Building grant. Recording with refce to
G.O. No. 165 Edl of 15.2.15 letters from the
D.P.I. recommending — for the Hindu
Theological High School, Madras.

Recommending a half grant for making certain additions and improvements to the accommodation of the Hindu Theological High School, Madras.

Submitting revised plans and estimates relating to the Hindu Theological High School, Madras and recommending that a half grant of Rs. 9,300 may be sanctioned on the total cost of the revised estimate.

Report to accompany the revised plans and estimates for the
Proposed additions and Improvements to the Hindu Theological
School, Madras.

S.P. 9. 42 B

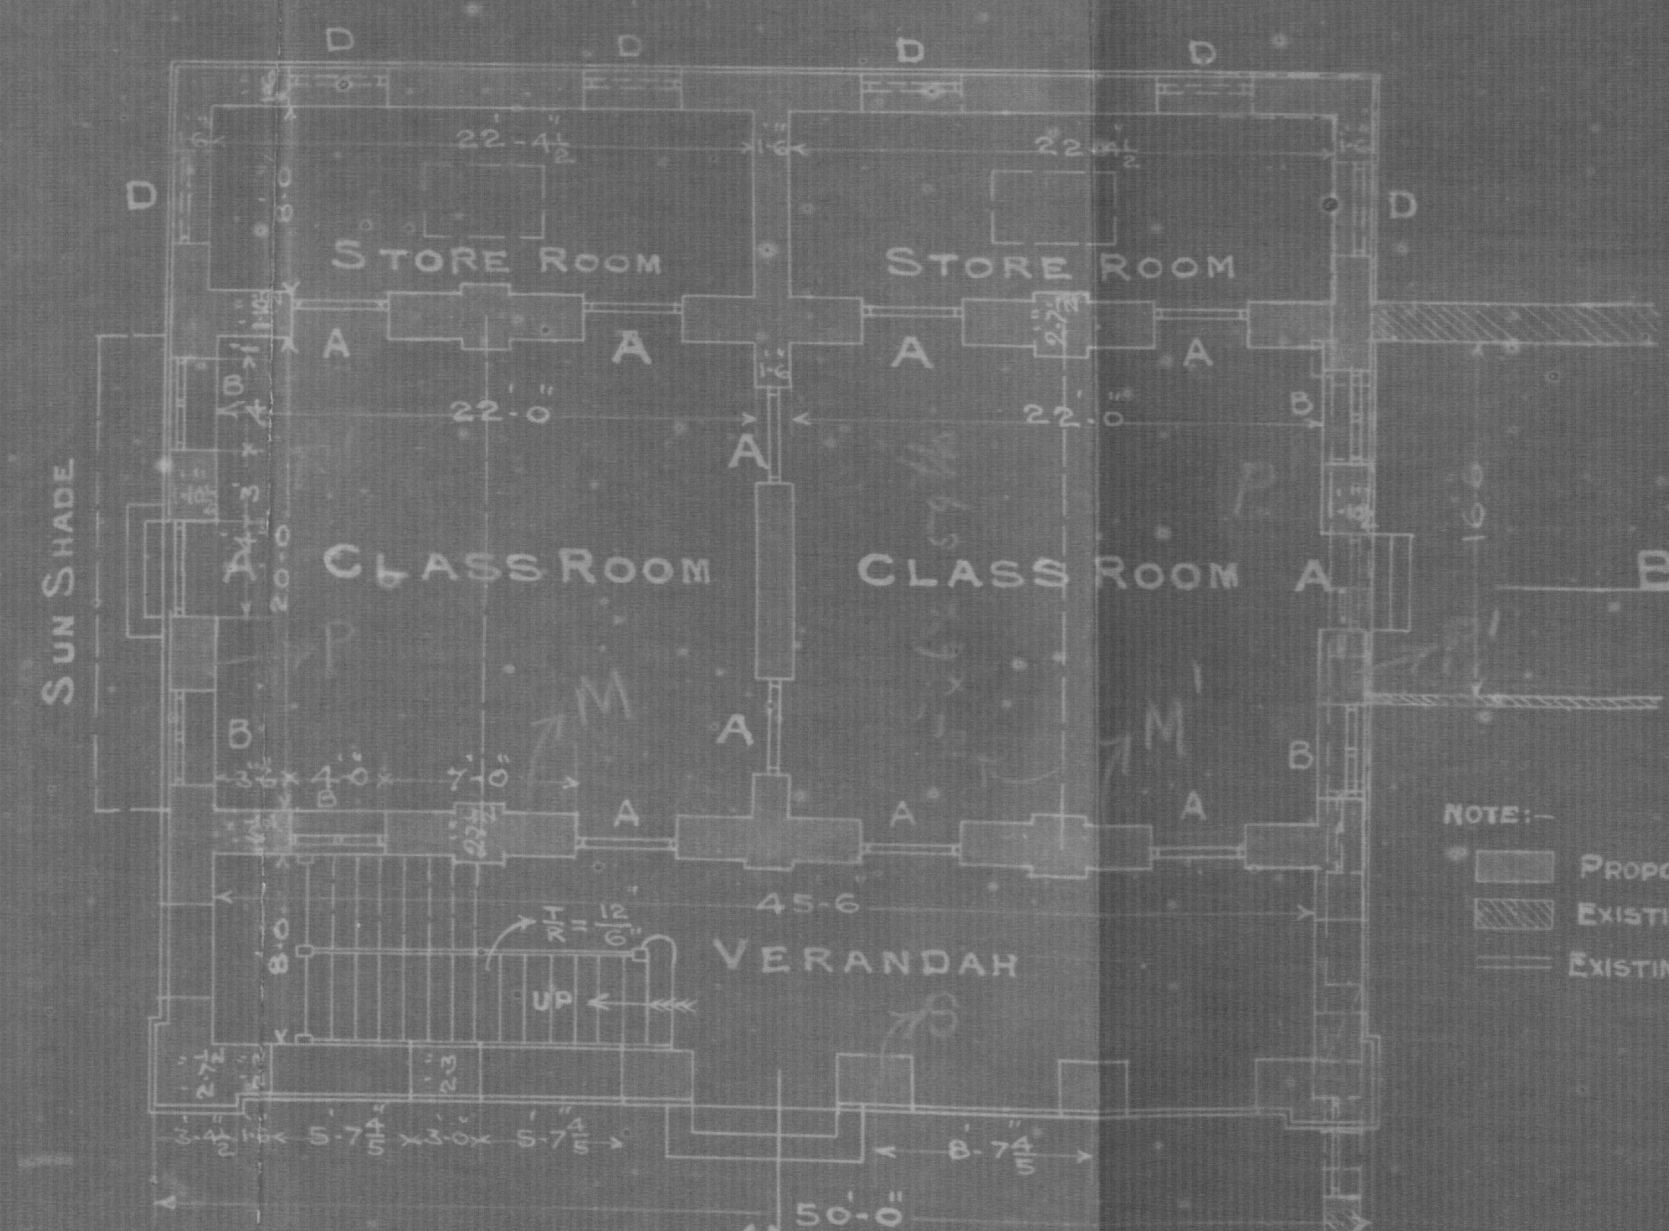
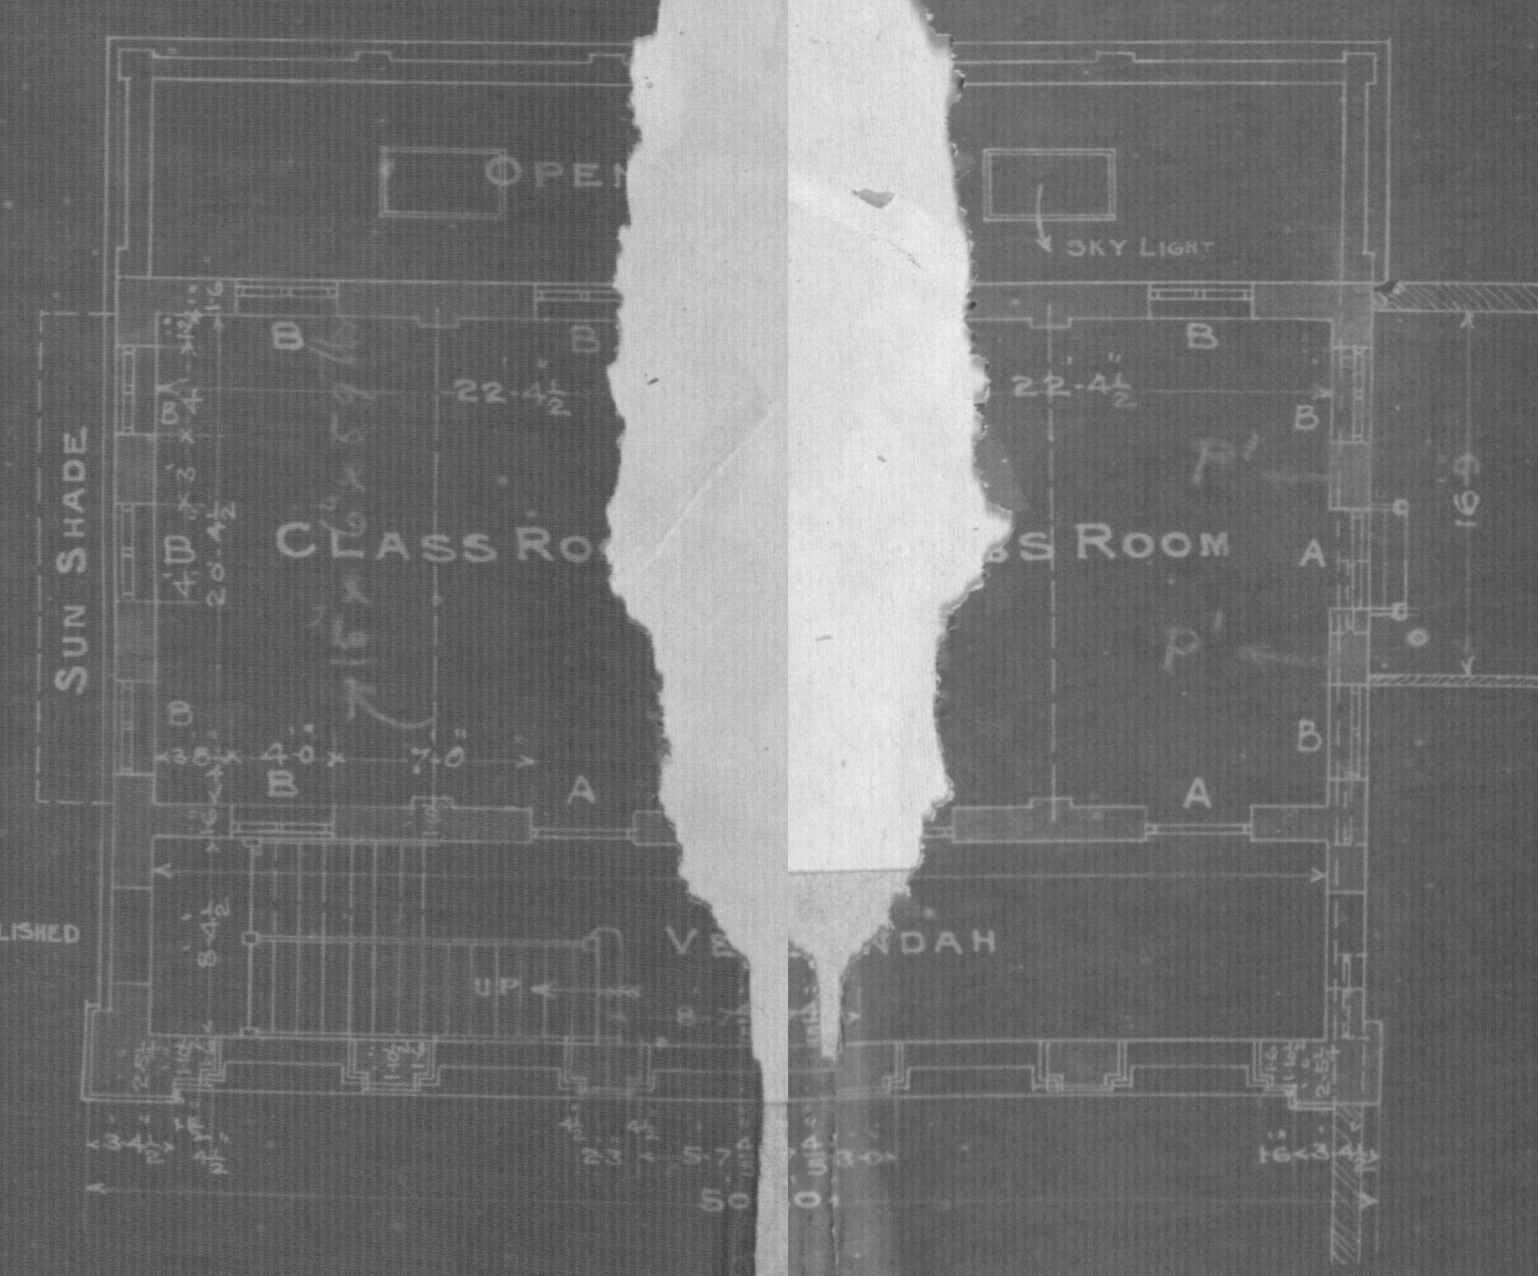
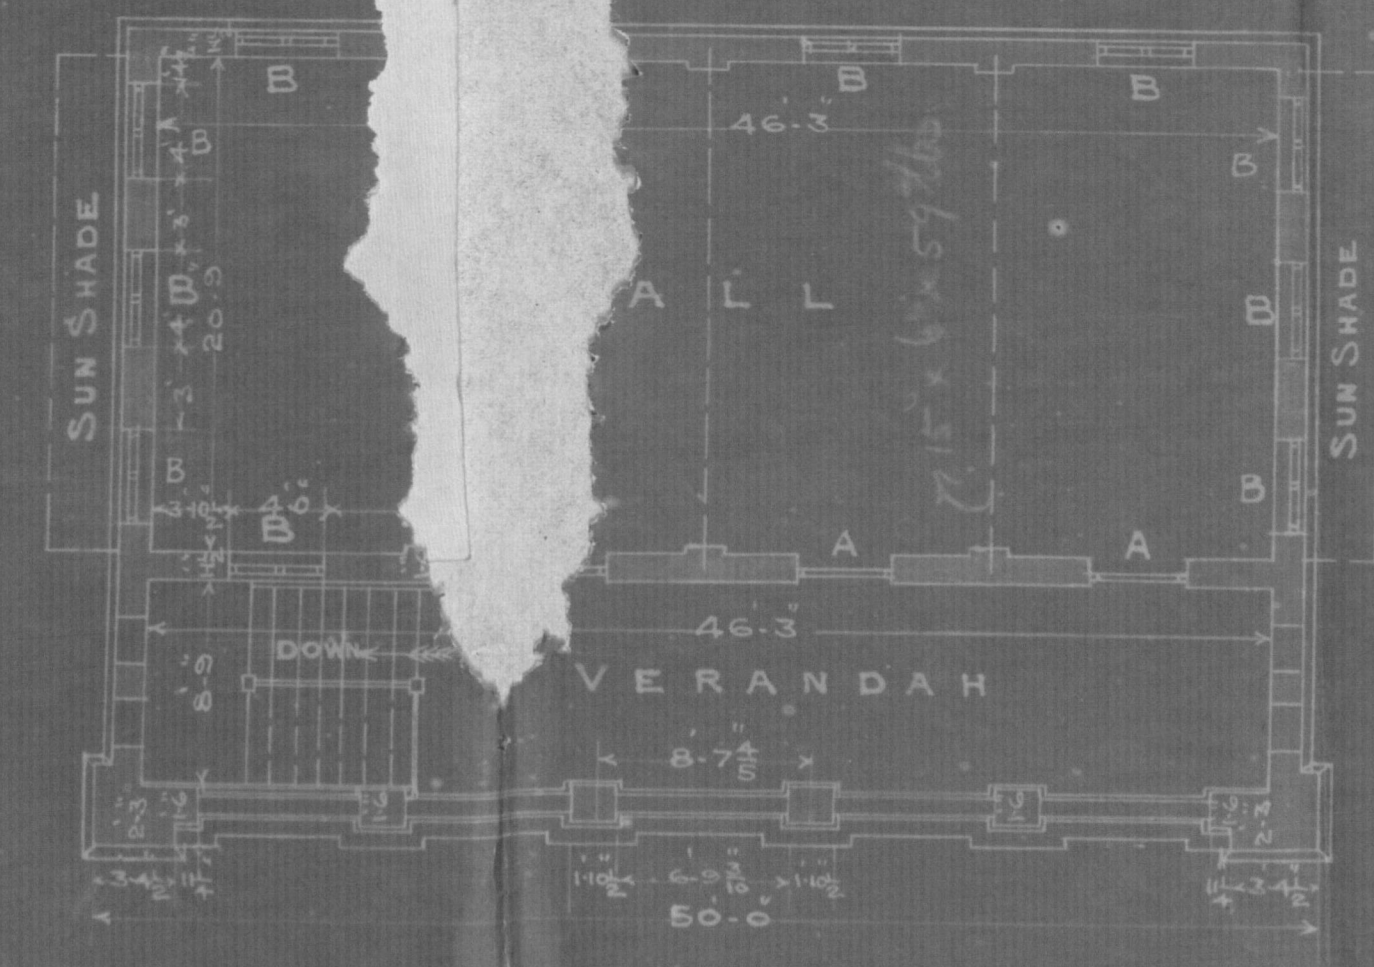
(1) Constructing piers marked P and P' on plan D.P.I.No.42-B with cement instead of lime mortar, the additional cost involved to be met from the amount provided for "unforeseen works."

III. The piers marked M & M' should be constructed with bricks carefully selected

- The plan marked M is to be constructed with solid brickwork.
- The new plan marked P & P on ground & 1st floor to be constructed with brick in cement.
